TOWN OF SOUTHBURY, CONNECTICUT
ADDENDUM NO. 1
REPLACEMENT OF BRIDGE NO. 130-009 OLD FIELD ROAD
OVER BULLET HILL BROOK

Bid Opening: Friday March 21, 2025
@ 10:00 AM

**TOWN OF SOUTHURY, CONNECTICUT
REPLACEMENT OF BRIDGE NO. 130-009
OLD FIELD ROAD OVER BULLET HILL BROOK**

Meeting Minutes

REPLACEMENT OF OLD FIELD ROAD CULVERT
OVER BULLET HILL BROOK
SOUTHURY, CONNECTICUT
CROSS SECTIONS

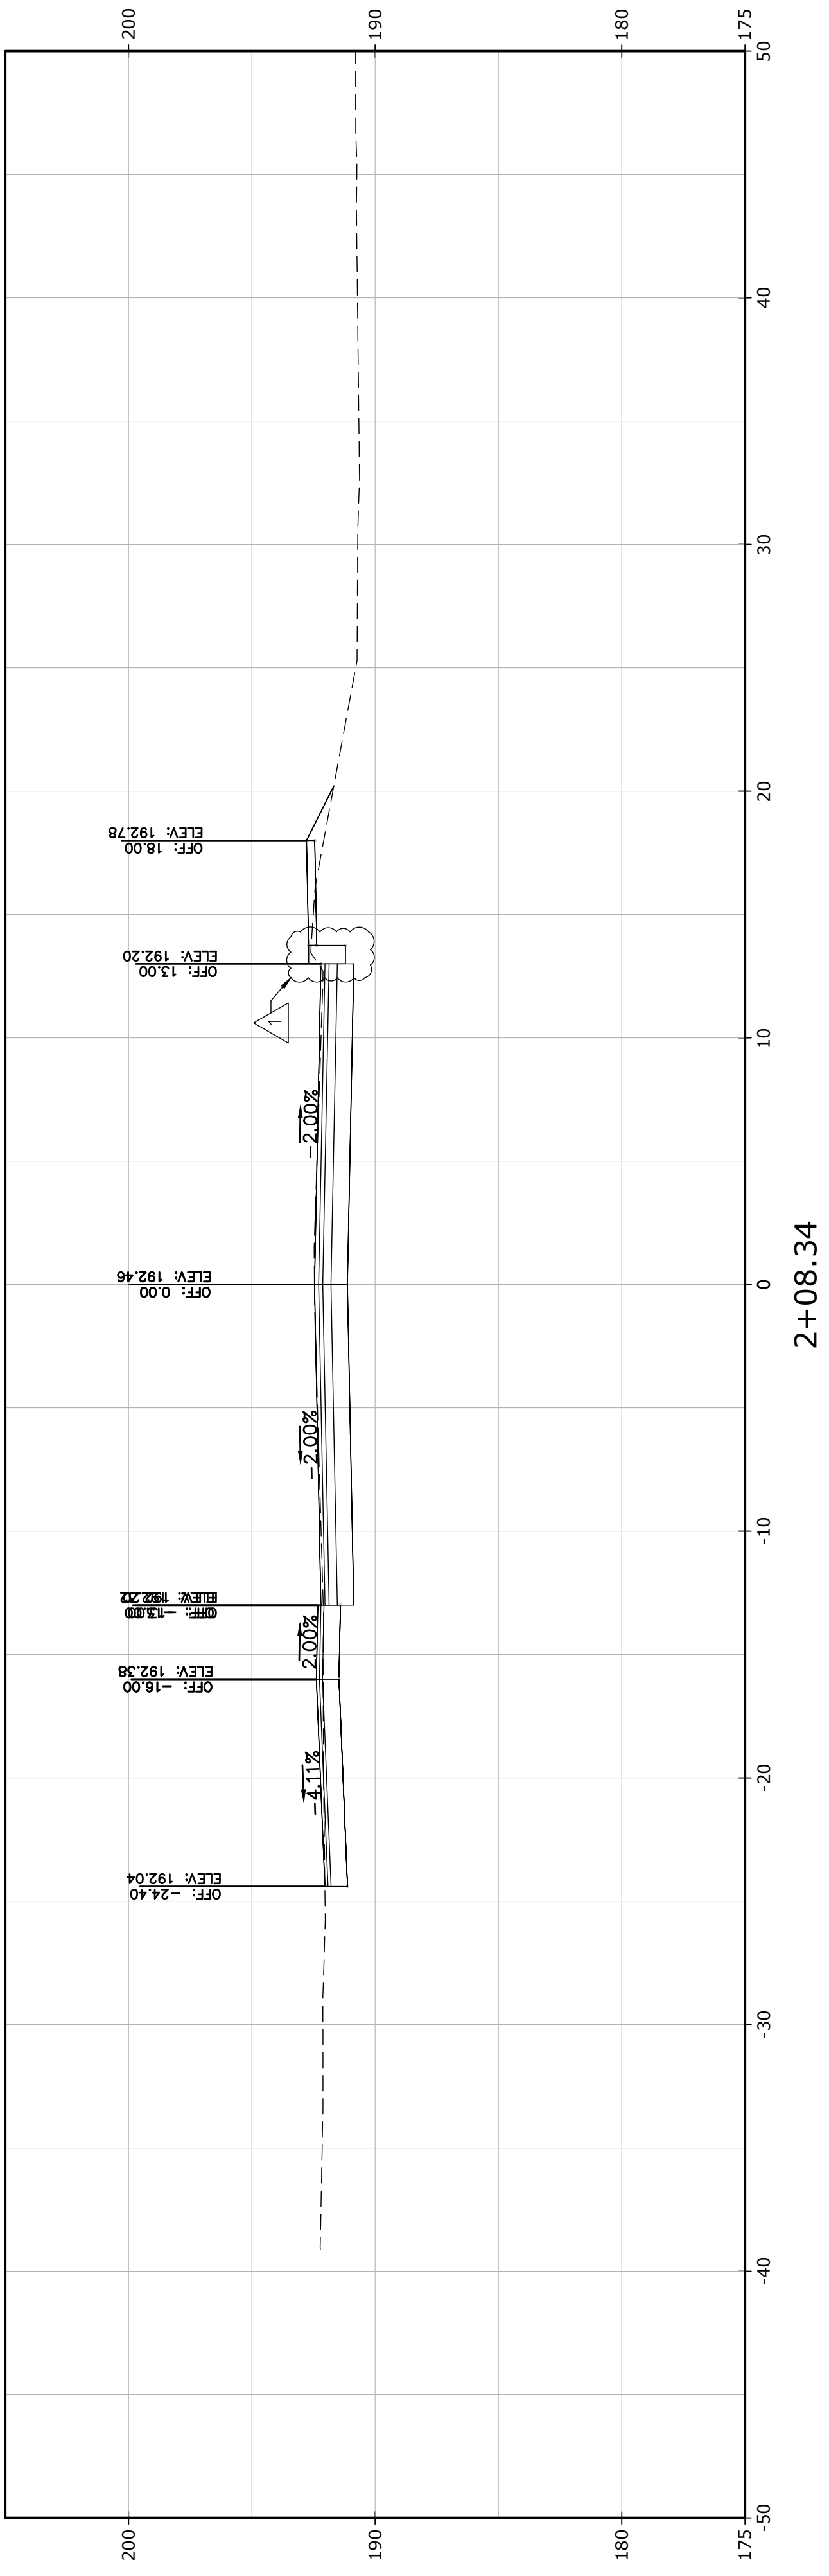
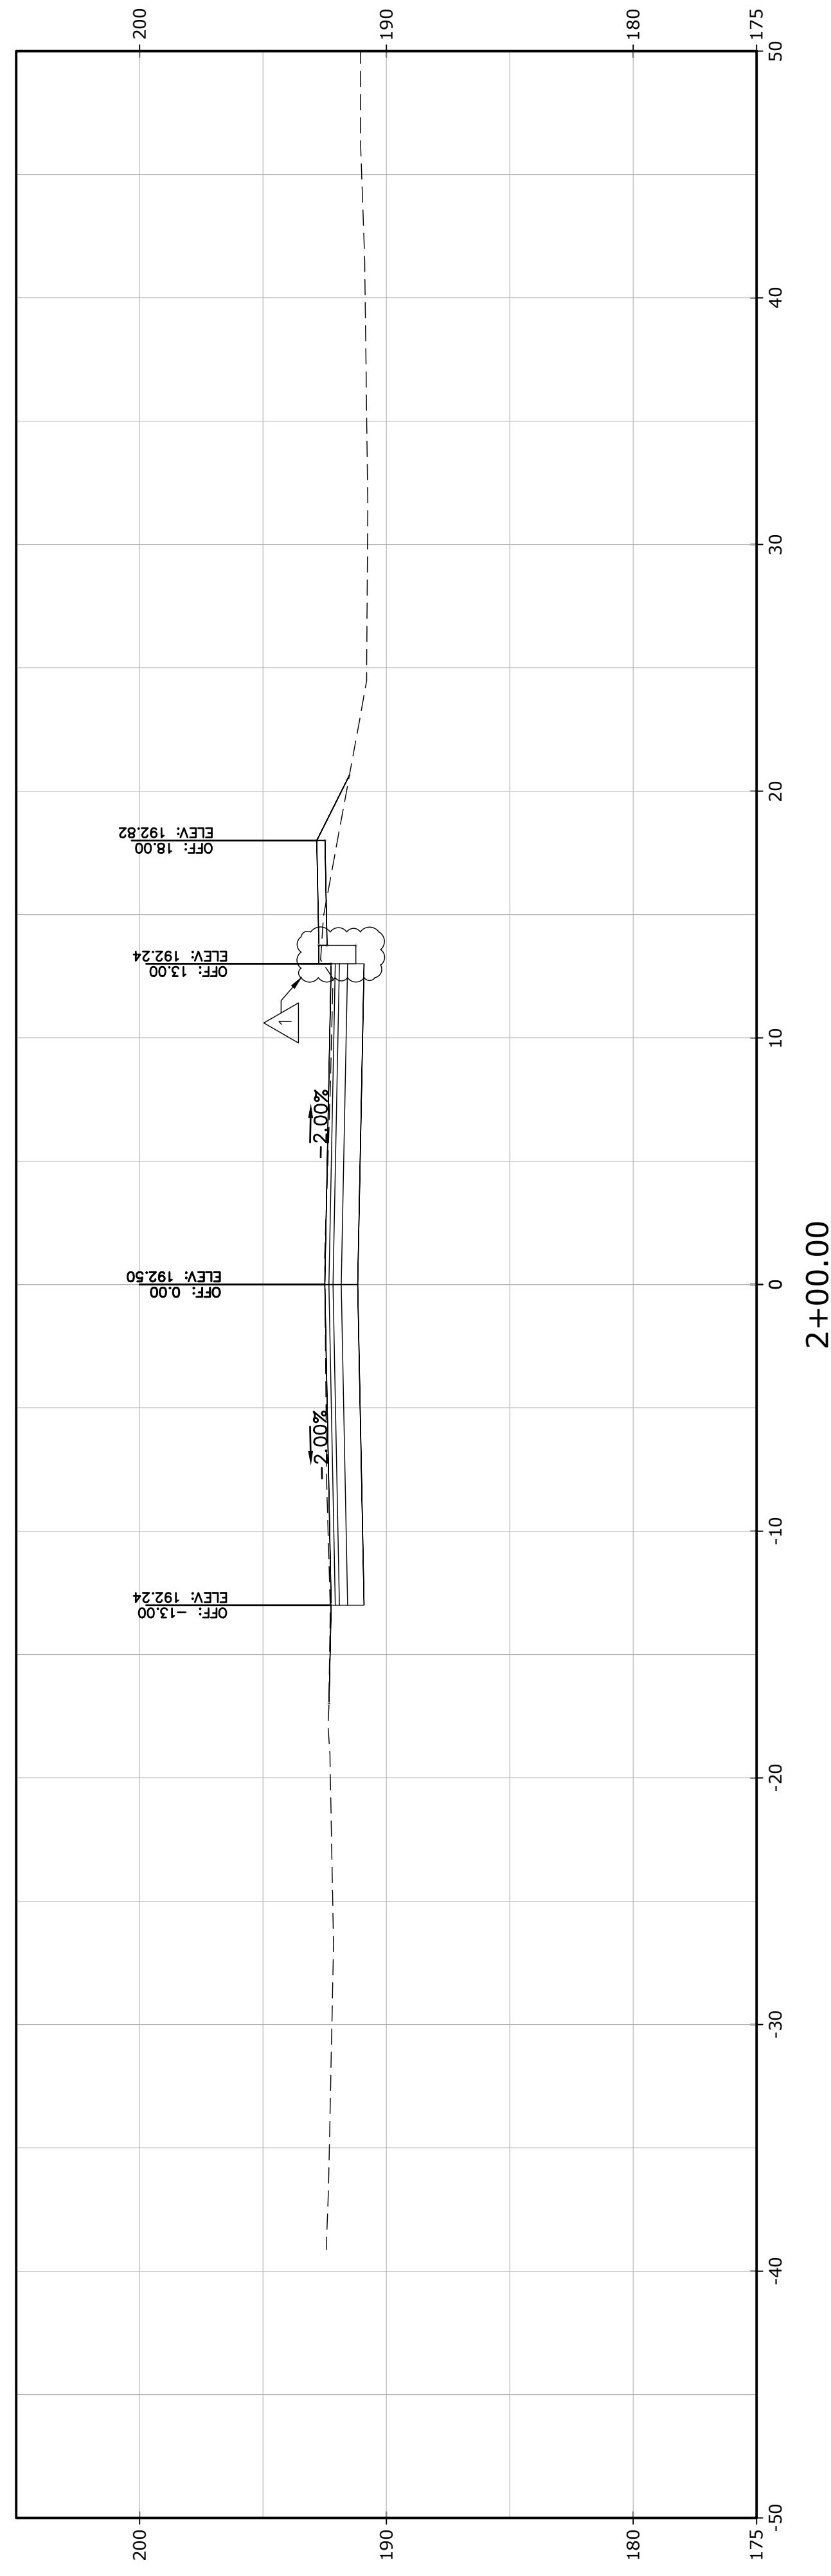
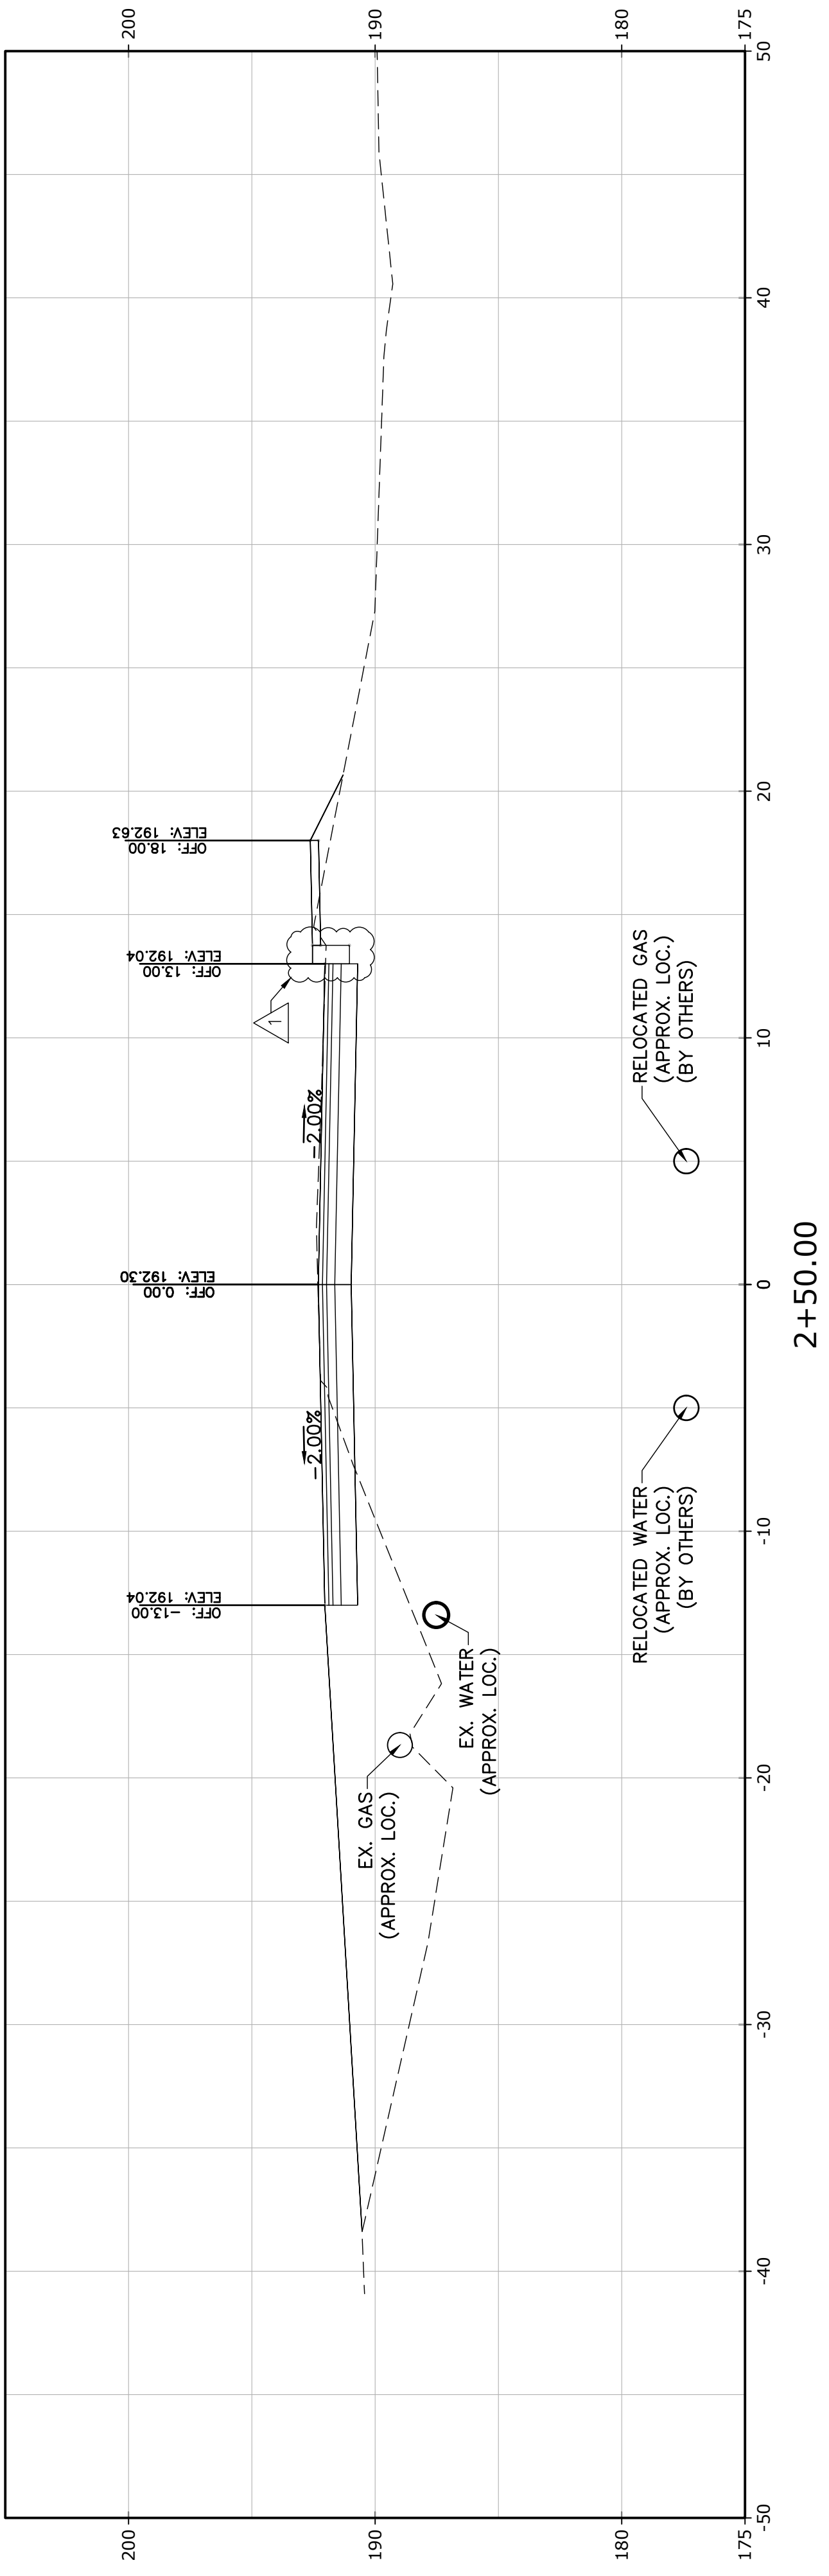
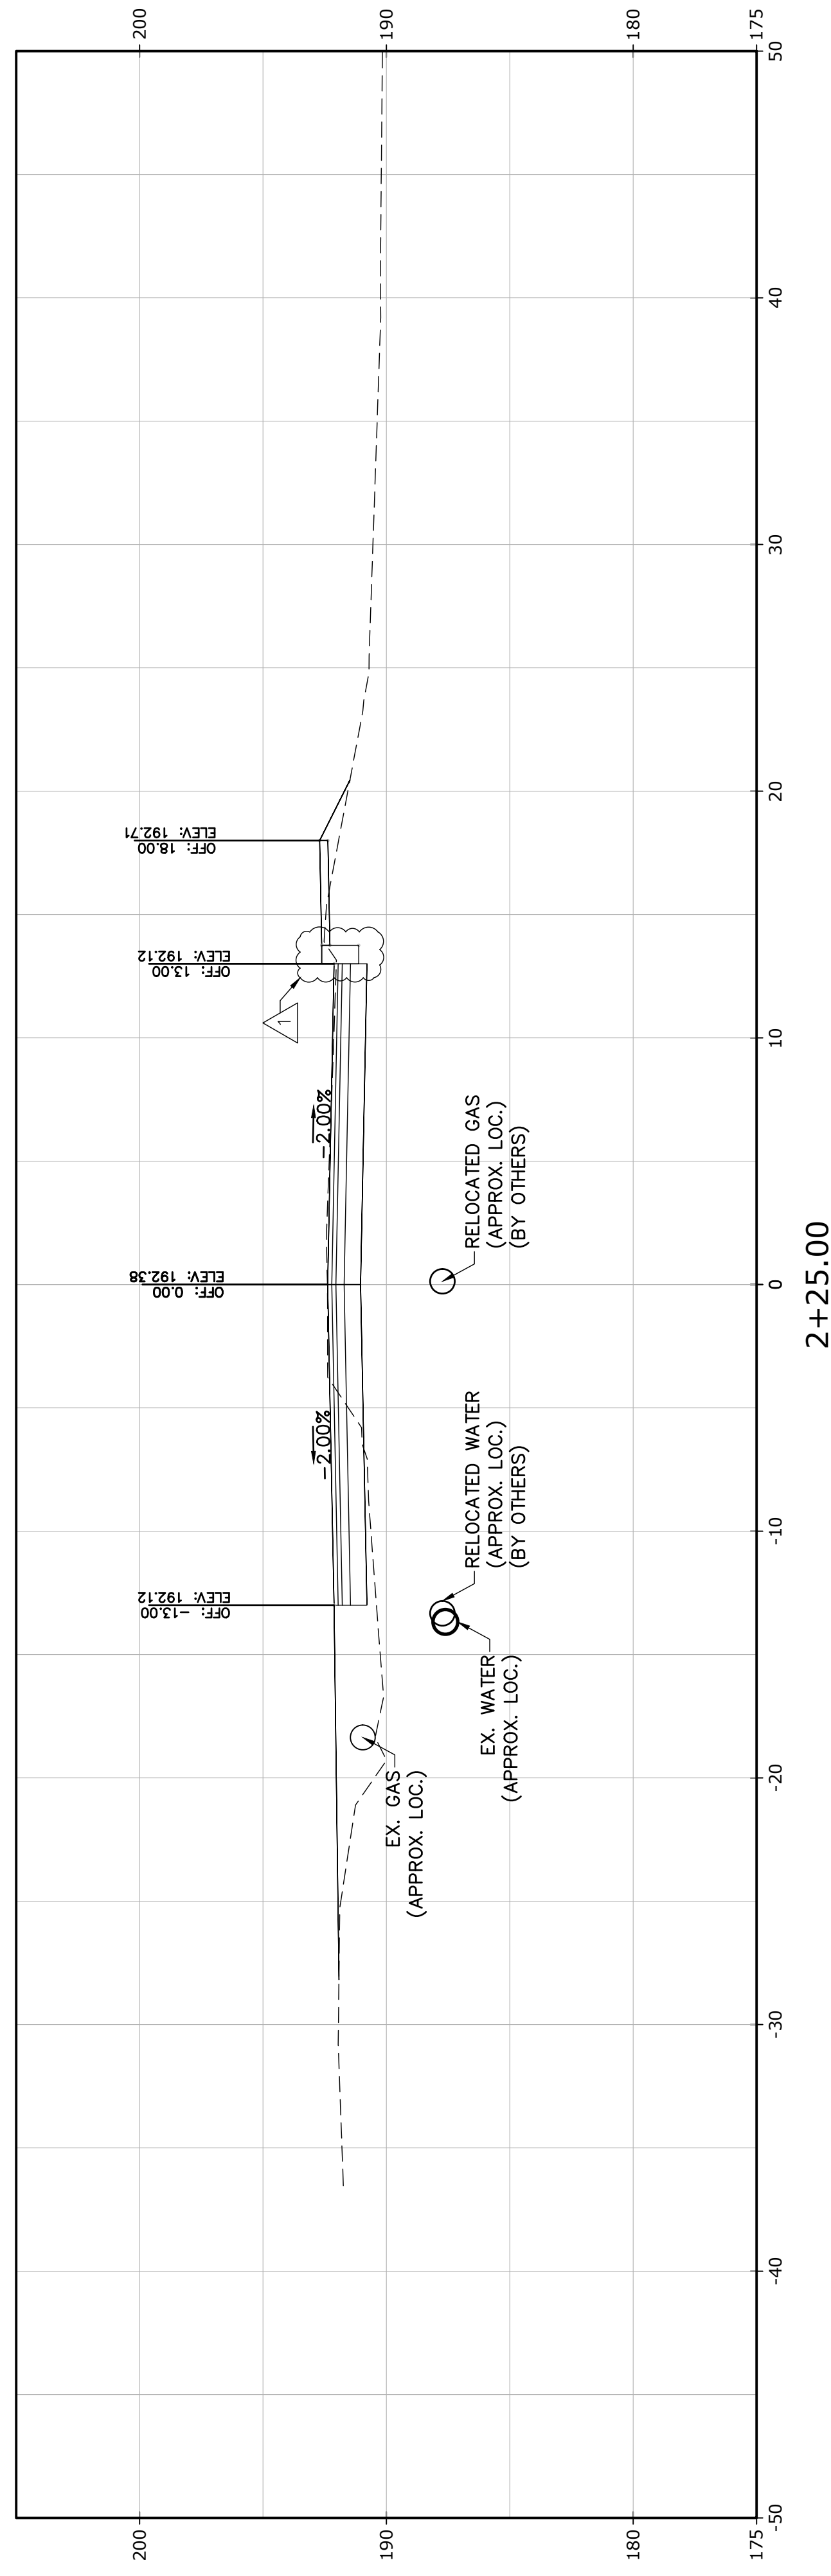
NO.	REVISION	DATE	BY
1	CURB REVISED	03/17/2025	CAD
